PLANT NAME: OCONEE UNITS 1 - 3
jcm 01/04/78

RE: Oconee Nuclear Station
Docket Nos. 50-269, -270, -287

The attached information is in response to questions forwarded in your letter of November 23, 1977 concerning the Steam Generator Tube Leakage Safety Assessment Report which was forwarded by my letter of September 9, 1977.

FIGURE 1: RCS AVERAGE COOLANT TEMPERATURE VS TIME

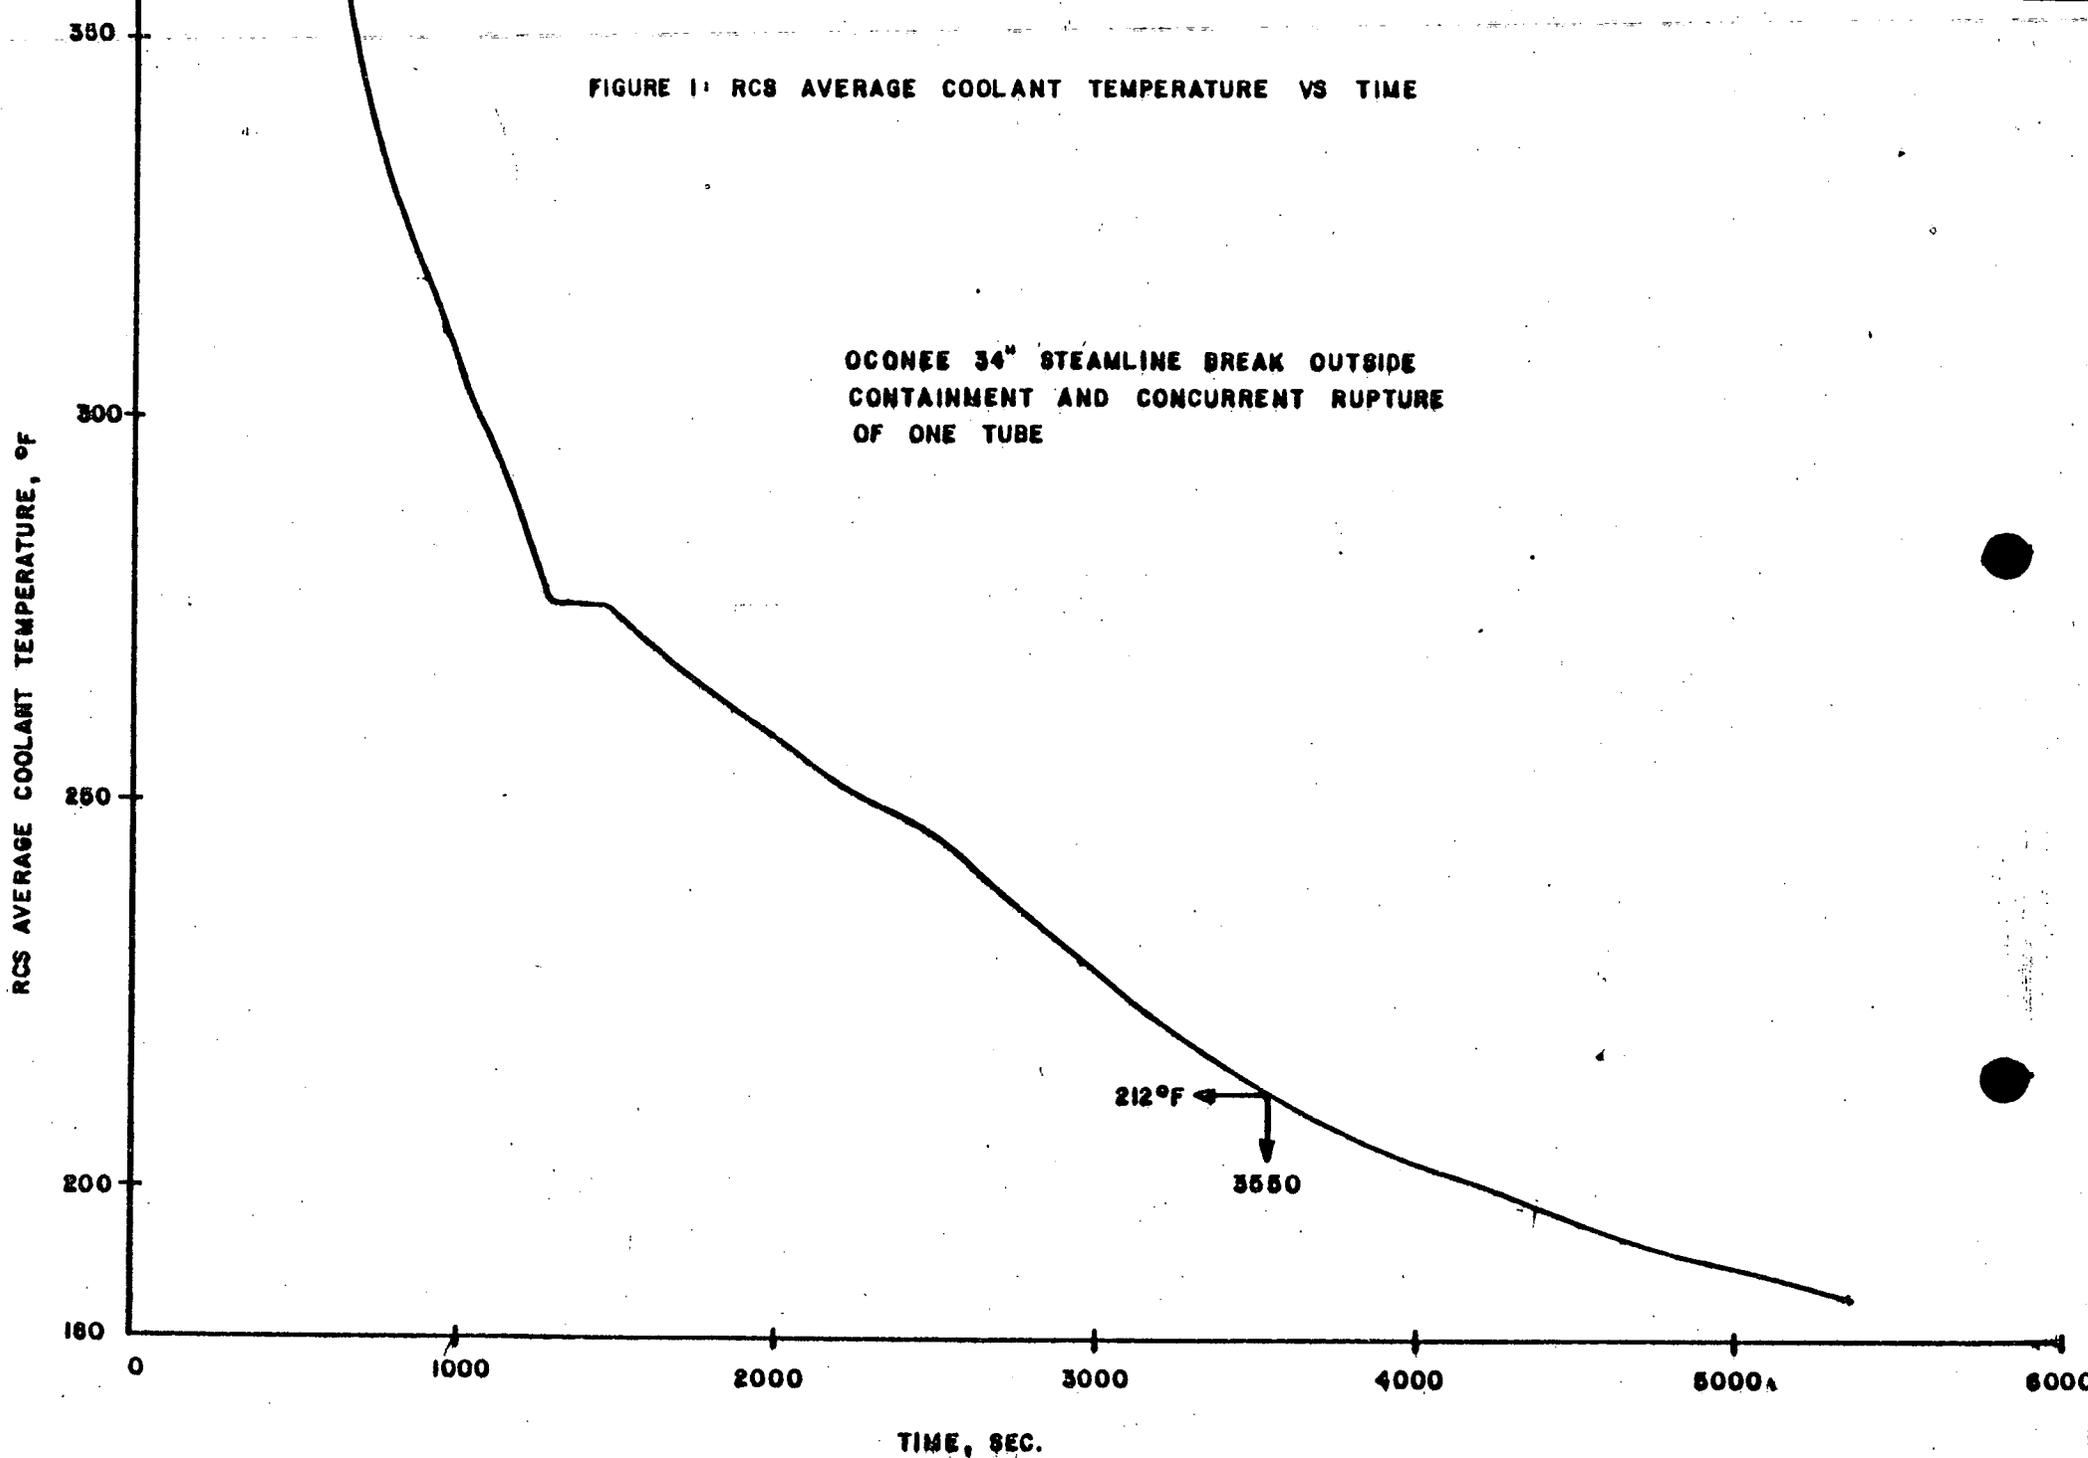
Your report states that operator action to switch off the safety injection would be conservative because it results in minimum dilution. Justify that this action is conservative. Explain the effect of delaying this action. The concern is that continuation of the safety injection will keep the system pressure at a higher level and would result in higher releases, in spite of the increased dilution.

This appears to be particularly important for the cases of one and three tube failures for which the leak rate is calculated to be increasing at a high rate at the time that the safety injection is switched off.

Analyze this accident assuming different times for operator action (e.g., 10 min., 20 min., etc.)

The calculated leak rates, RCS coolant temperature, and RCS pressure beyond 600 seconds are shown in the Figures 1 through 3 respectively. The average coolant temperature of 212°F is reached by 3450 seconds. The primary pressure reaches 25 psia by 5368 seconds corresponding to a total leak rate of 4.82 lbm/sec which was assumed constant thereafter. Once the RCS temperature falls near 212°F, the secondary side of the steam generator would start filling with water.
